DEFENSE NUCLEAR AGENCY  
ARMED FORCES RADIOBIOLOGY RESEARCH INSTITUTE  
BETHESDA, MARYLAND 20814-5145

10CMR 50.36  
DOCKET 50-170

May 17, 1991

SUBJECT: Additional Information on Proposed Technical  
Specifications Changes for License No. R-84.

Figure 1. Organization of Personnel for Management and Operation of the AFRRI Reactor Facility. Any reactor staff member has access to the Director for matters of safety.

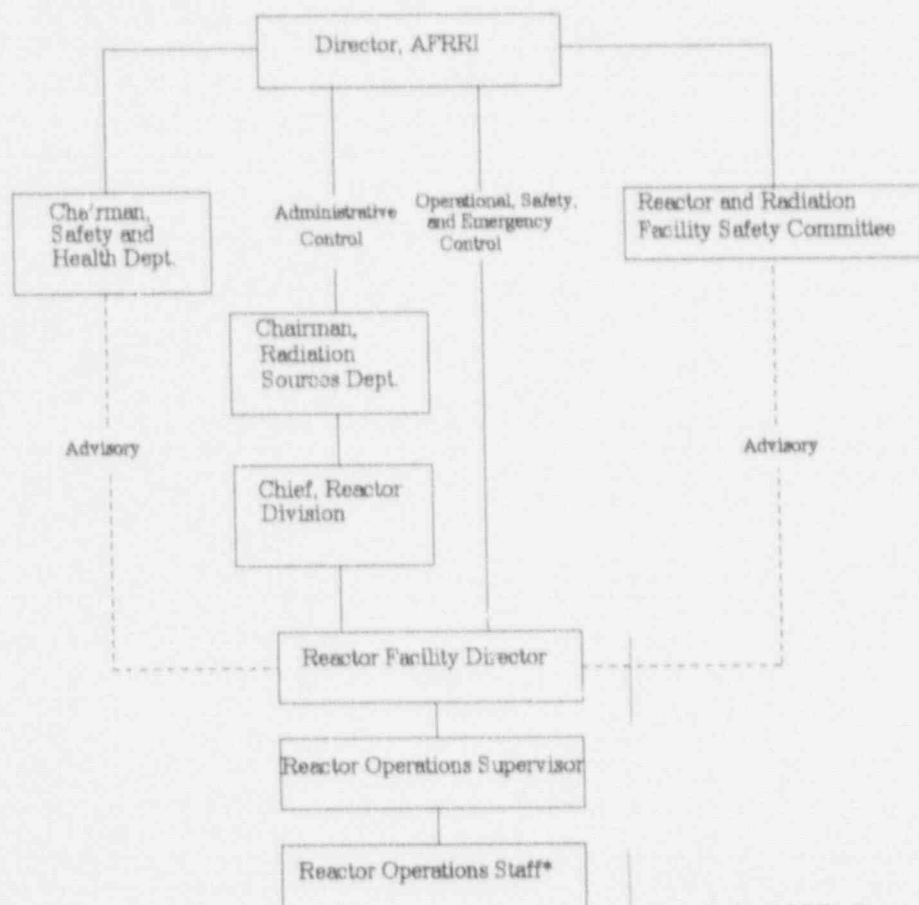
In your submittal of April 4, 1990, you describe changes to Section 6.1.1 of the TS. However, there are additional changes to Figure 1 that you do not describe or justify. Please explain and justify all of the changes made on Figure 1.

All changes to Figure 1 in Section 6.1.1 are administrative changes to reflect changes in existing terminology. There are no safety implications. Please replace "Chief, Radiation Sources Division" with "Chief, Reactor Division" and "Reactor Staff" with "Reactor Operations Staff".
